Subject: Qualcomm TrailerTRACS Wiring

Models Affected: Specific Freightliner Cascadia vehicles manufactured January 1, 2010, through January 14, 2013.

Daimler Trucks North America LLC, on behalf of its Freightliner Trucks Division, is initiating Field Service Campaign SF480A to modify the vehicles mentioned above.

June 2013
SF480A
REVISED NOTICE

Fig. 5, Wiring Modification Parts

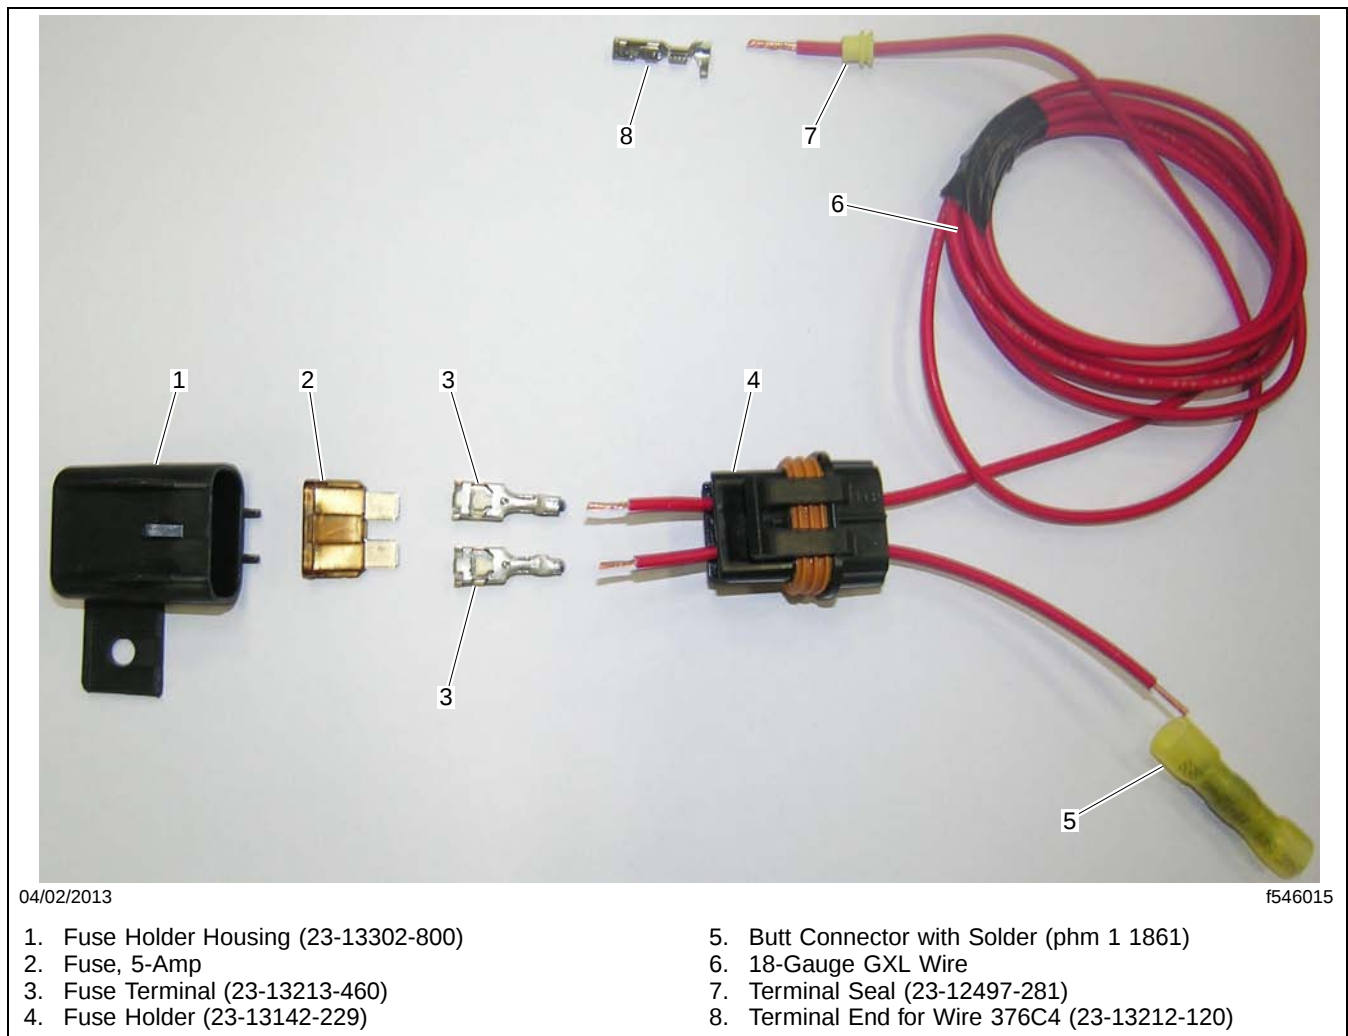
6. Assemble the harness from the parts provided in the kit. See **Fig. 5**
 - 6.1 Measure and cut enough 18-gauge wire to extend from the driver-side wall under the bunk to the passenger-side wall, and under the passenger-side kick panel to the Qualcomm ECU connector under the dash.
 - 6.2 Feed the wire through the fuse holder. Strip the wire, then crimp on the fuse holder terminal end.
 - 6.3 Cut a 4 to 6 inch (10 to 15 cm) strand of wire.
 - 6.4 Feed the short strand of wire through the fuse holder. Strip the wire on both ends, then crimp on the fuse holder terminal end.

Fig. 6, Wire Re-Routed to Qualcomm ECU

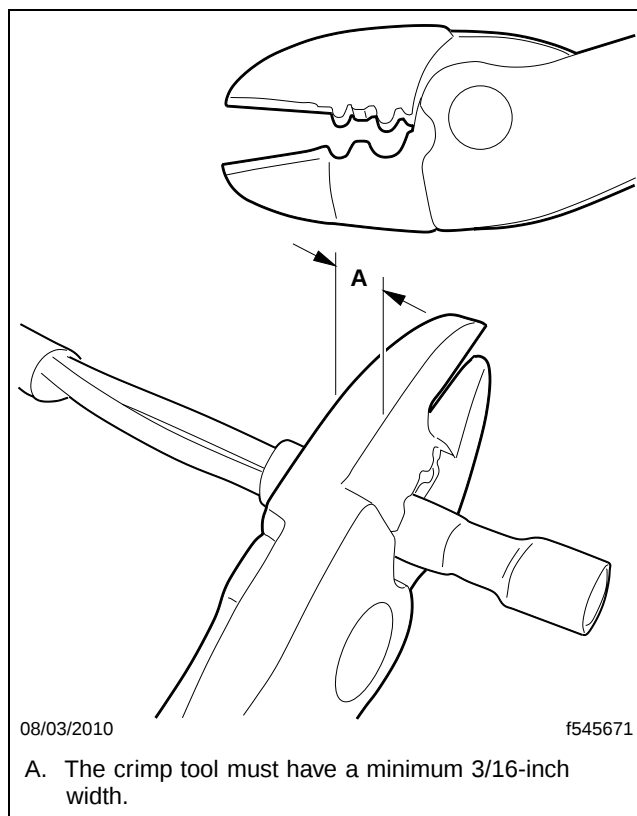
7. Inside the cab, cut and strip the circuit 45 blue wire.
8. Splice the new wire into circuit 45. See **Fig. 6**.
 - 8.1 Slide a butt connector onto the the end of circuit 45 that leads to the SAM Chassis.
 - 8.2 Slide the new wire and the other end of circuit 45 into the opposite end of the butt connector.
 - 8.3 Crimp each end of the butt using a crimp tool to secure the wires. See **Fig. 7**.
 - 8.4 Pull test the wires by hand to ensure the crimp is mechanically solid.
 - 8.5 Heat the splice using a heat gun rated at 1,000°F (538°C) until the sleeve has completely shrunk against the wire and the solder inside the butt connector flows.

Fig. 11, Qualcomm Connector Wire Location

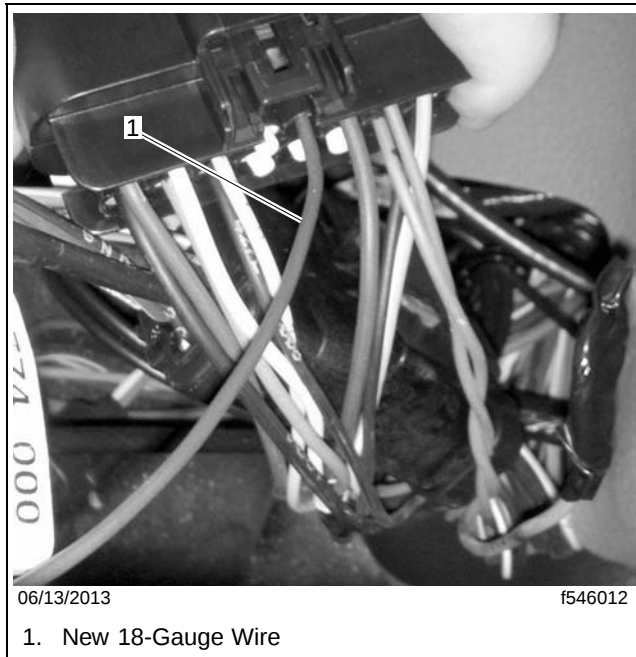
14. Insert the new wire into the Qualcomm connector in the same cavity where wire 376C4 was connected. See **Fig. 11**.
15. Tape down the new wire along the inner bunk support, along the cab wall and the passenger-side door frame. See **Fig. 12**.
